Service Bulletin

RRP Service Bulletin No: RRP SB394

Title: ATPI Dual PO Check Valve Kit

Product Series: Advanced Tie Plate Inserter [ATPI]

DWG SIZE	CATALOG	DWG NO
D	K	793210

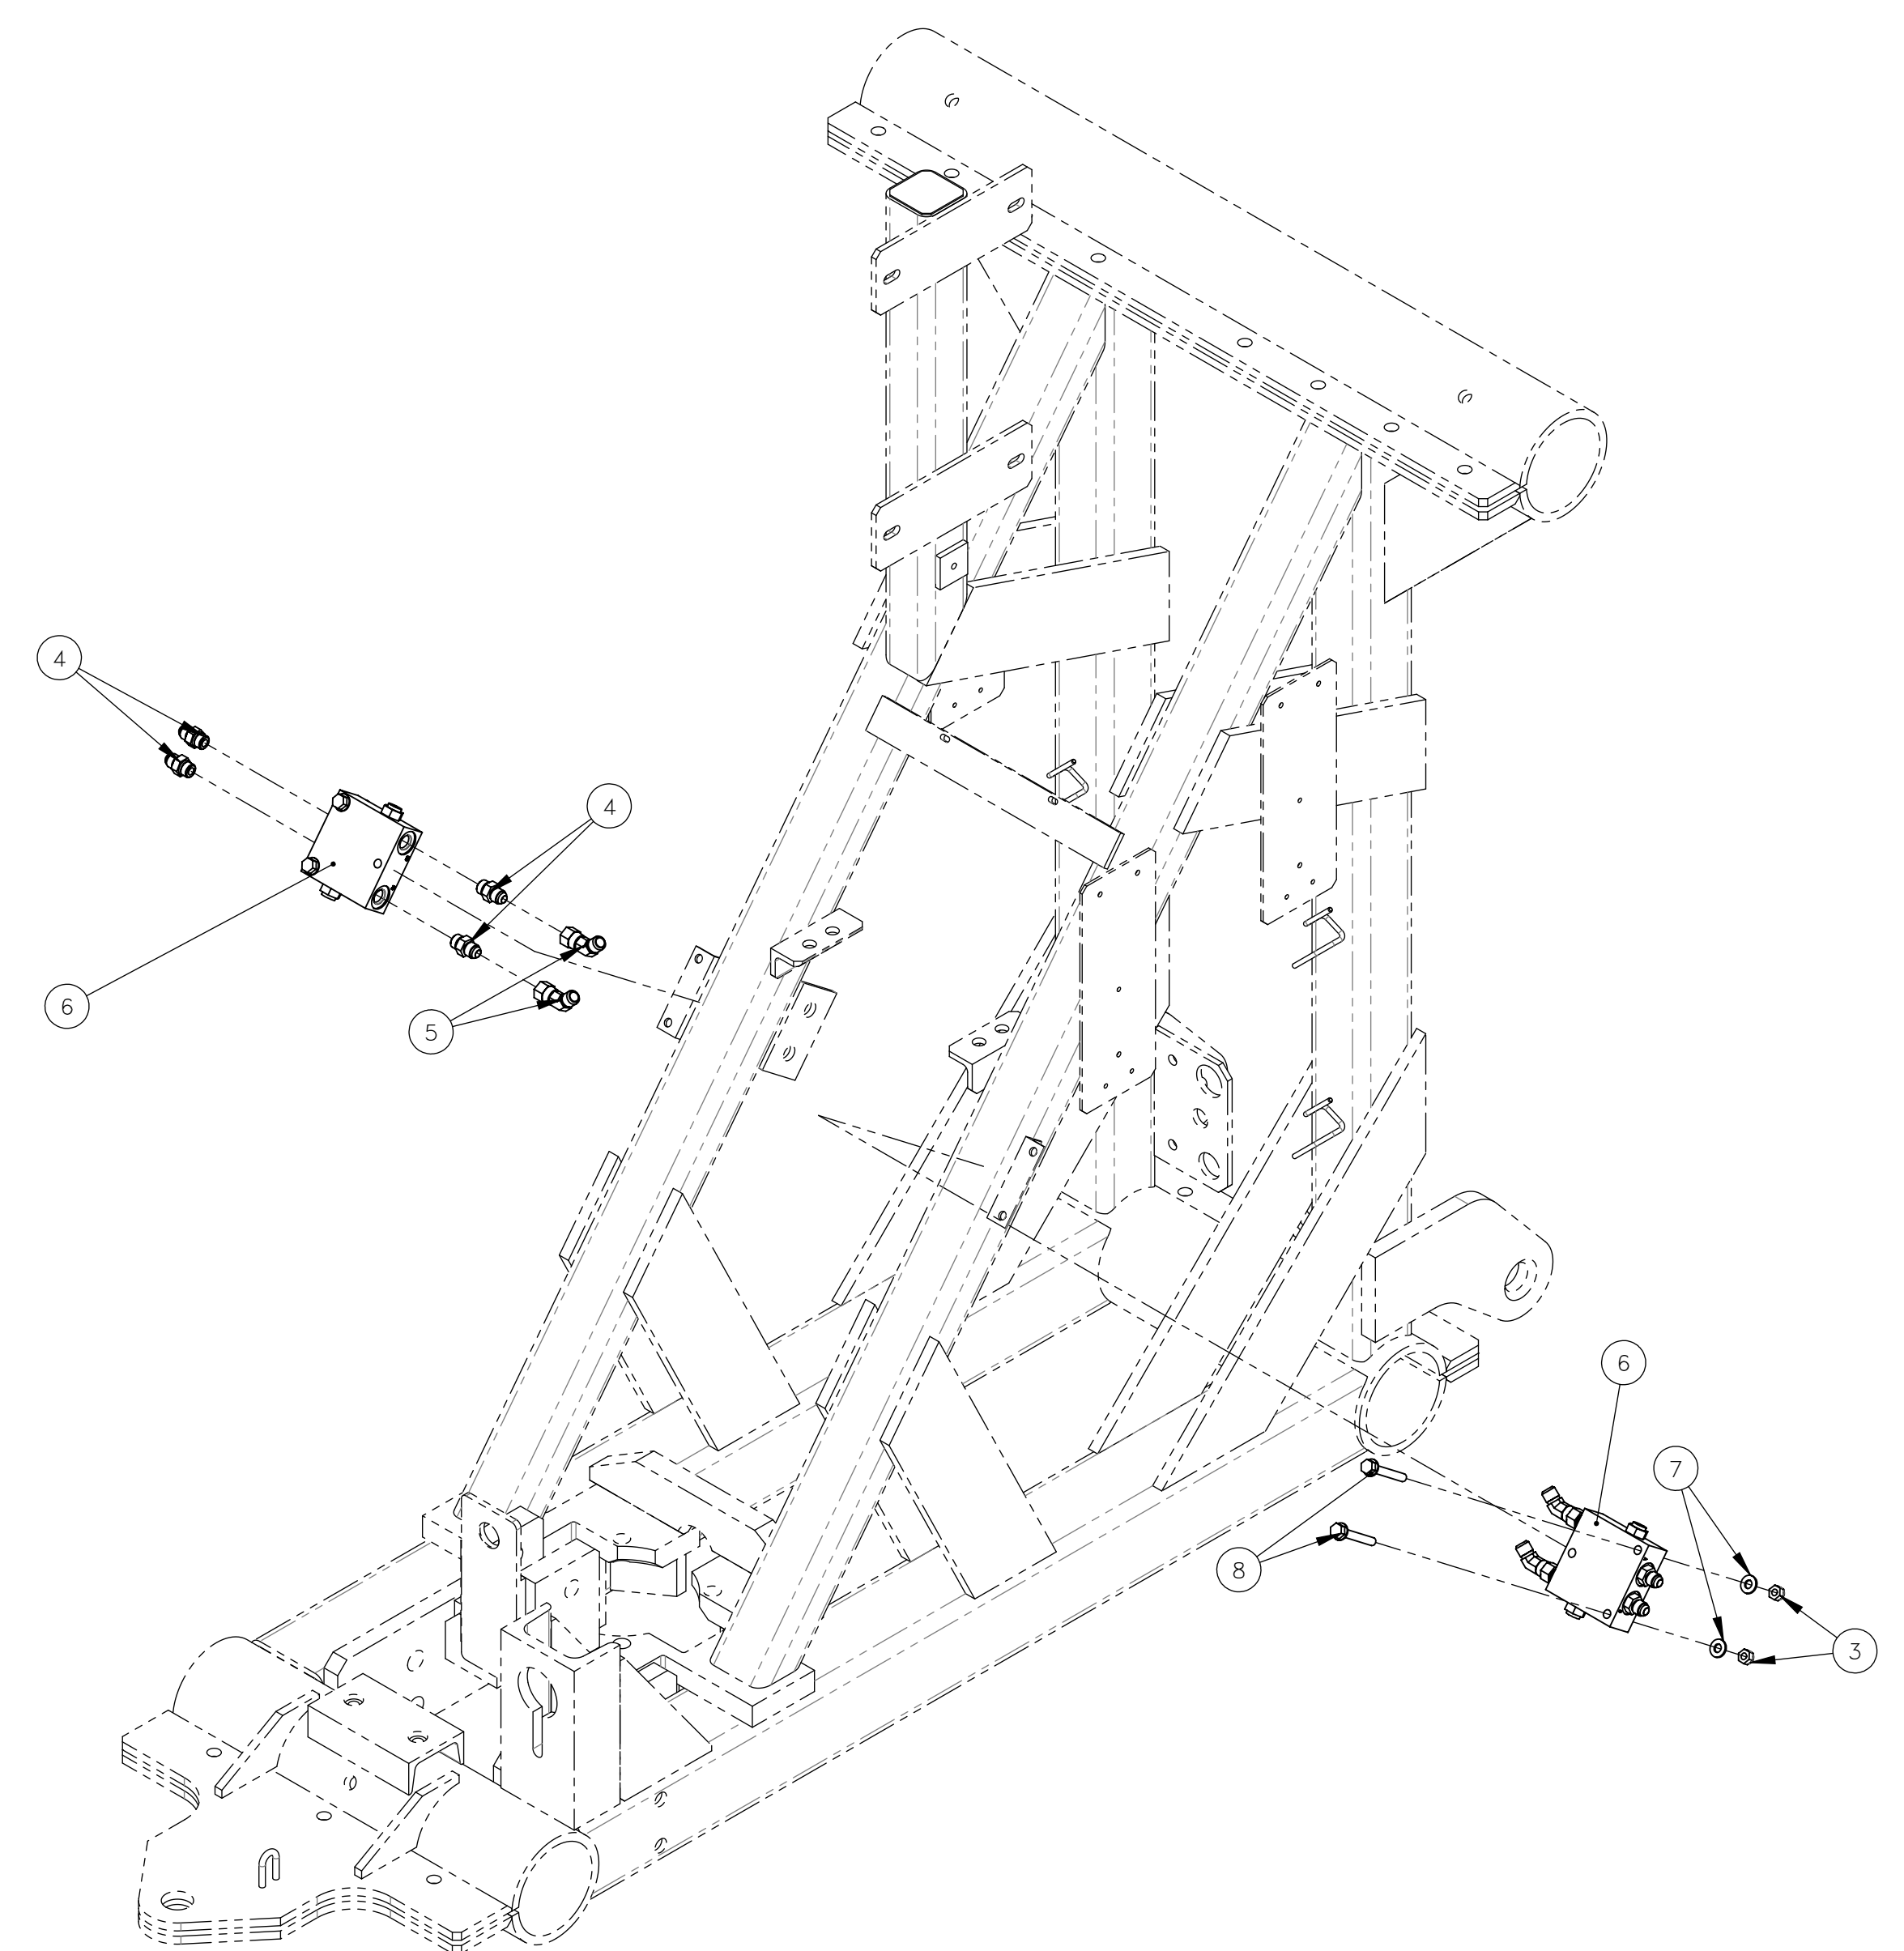
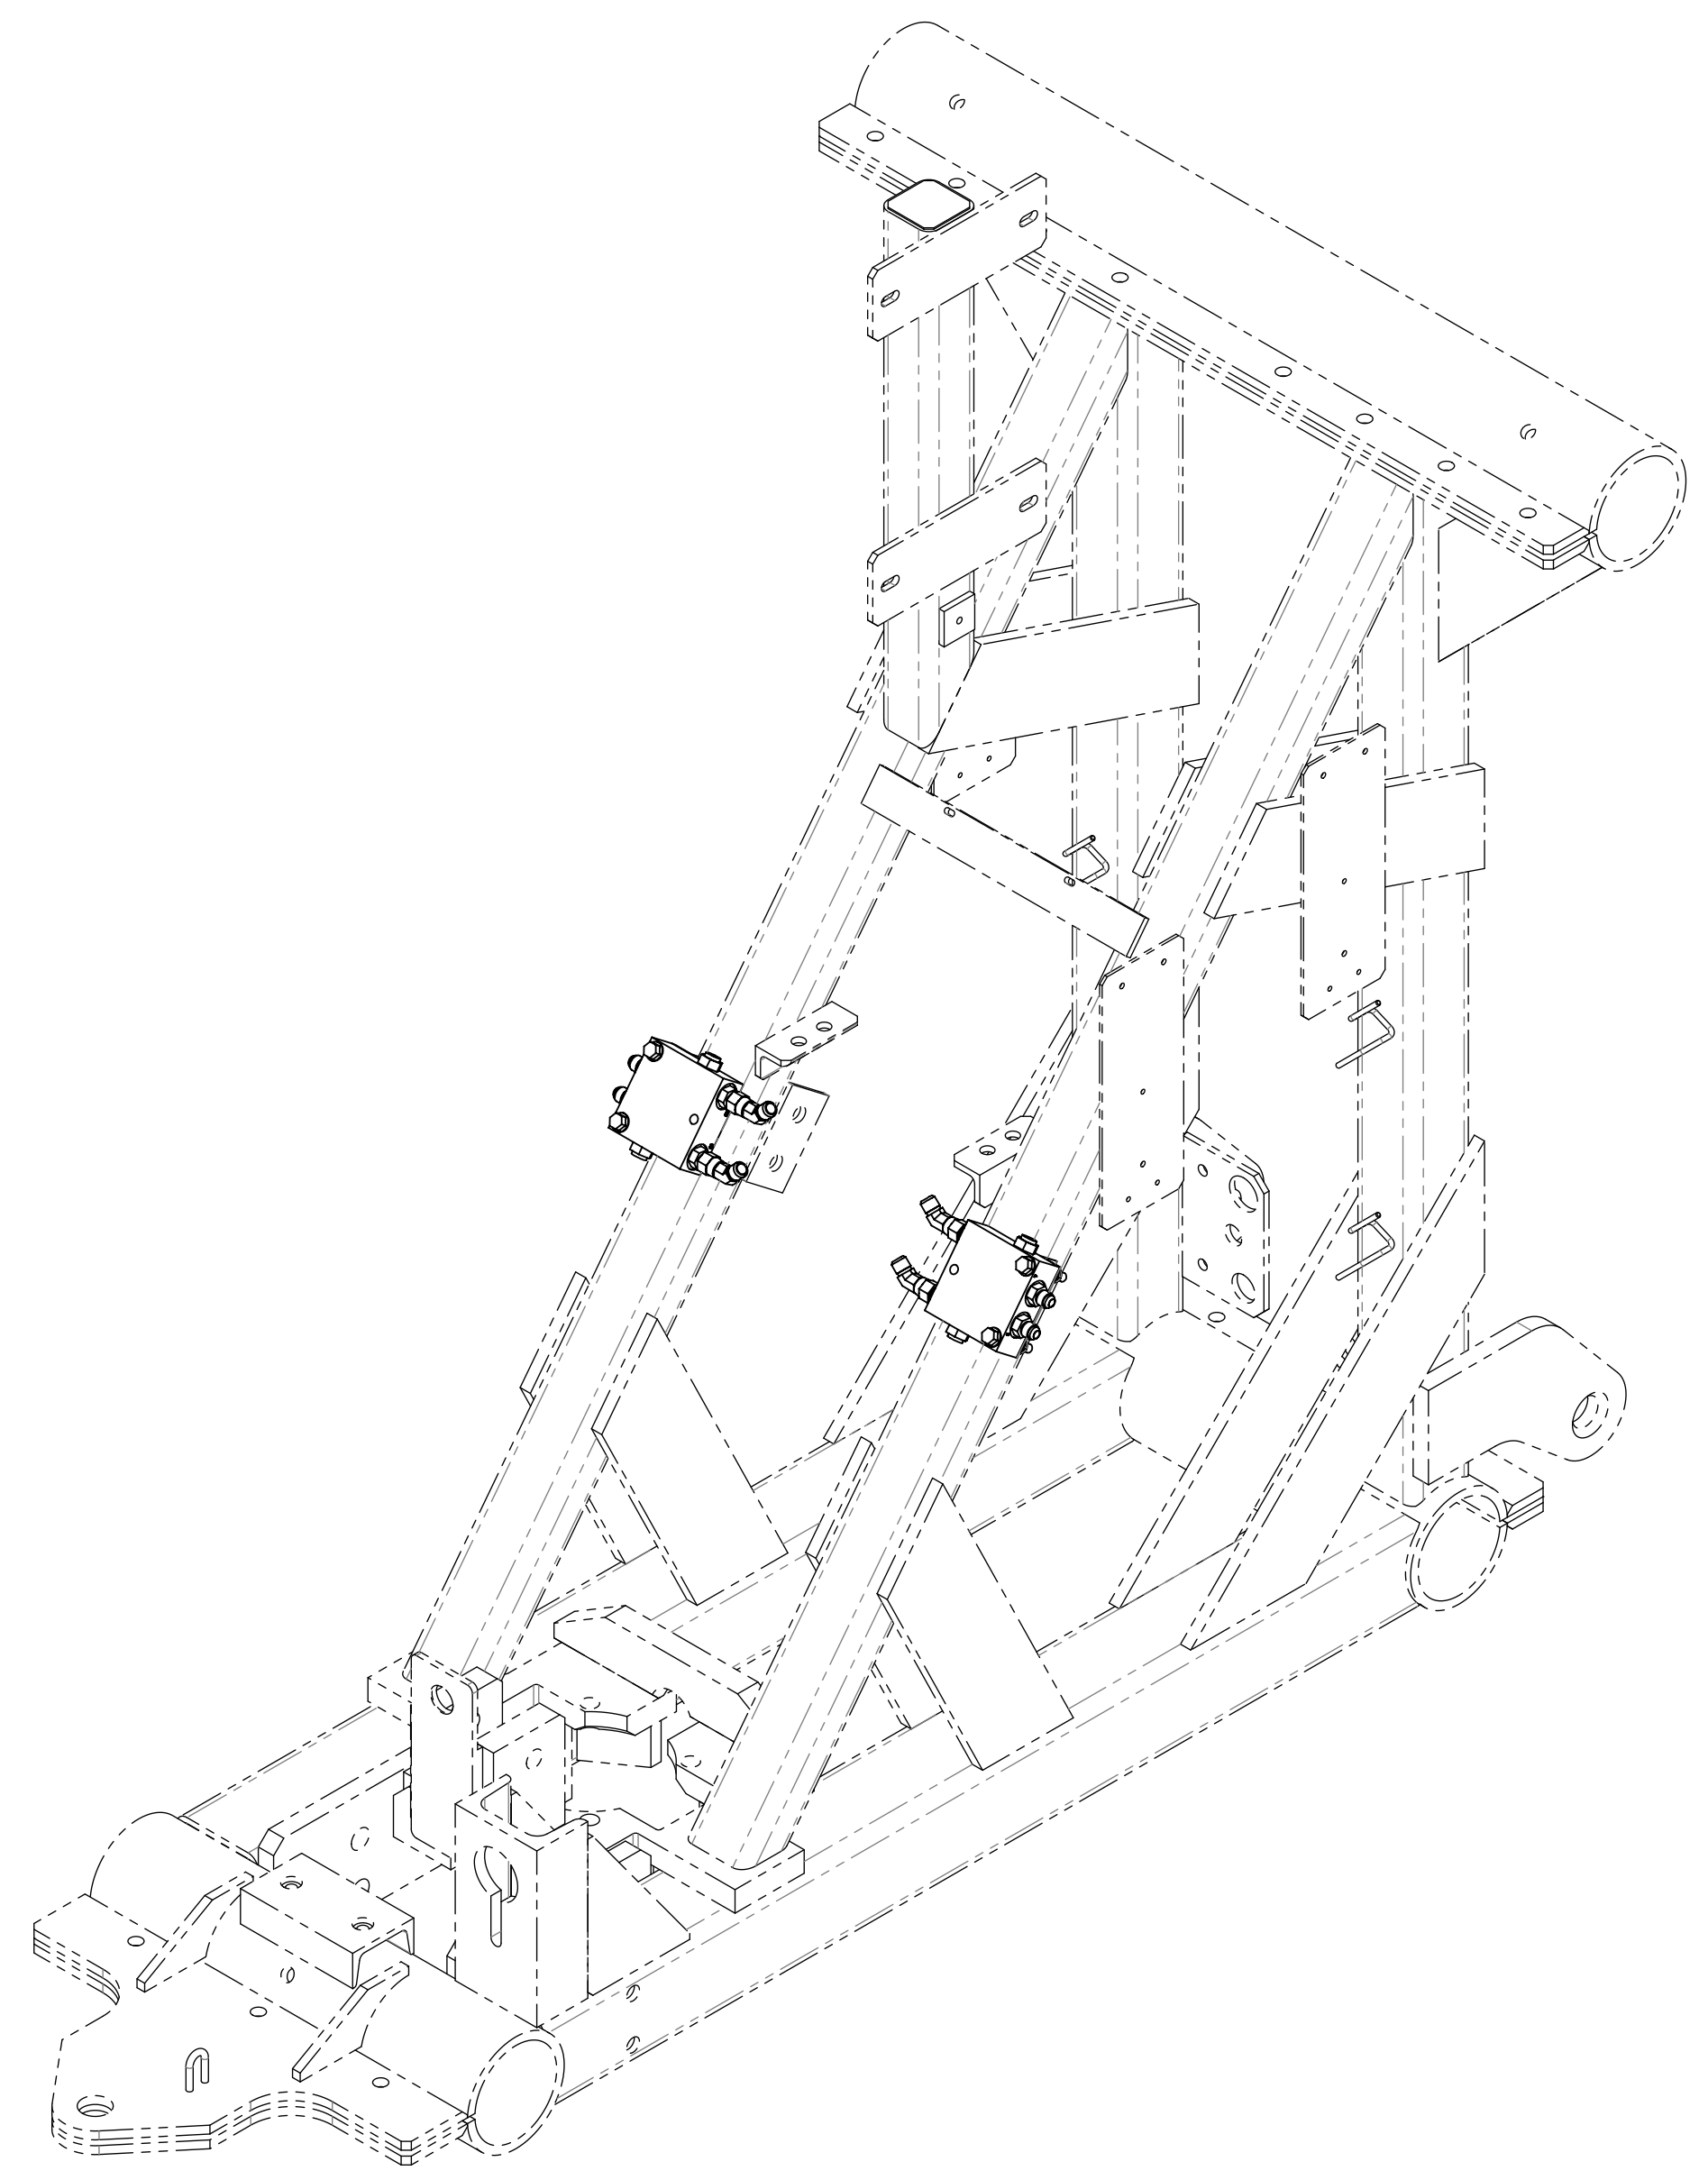
Summary: Machines need to have a PO check kit installed to prevent the center insert cylinders from drifting out during field insert operation.

Action: Install Kit # 793210 ATPI Dual PO Check Valve Kit. See attached sheets for details.

Completion / Resolution: Continue with normal machine operation after installing service kit 793210.
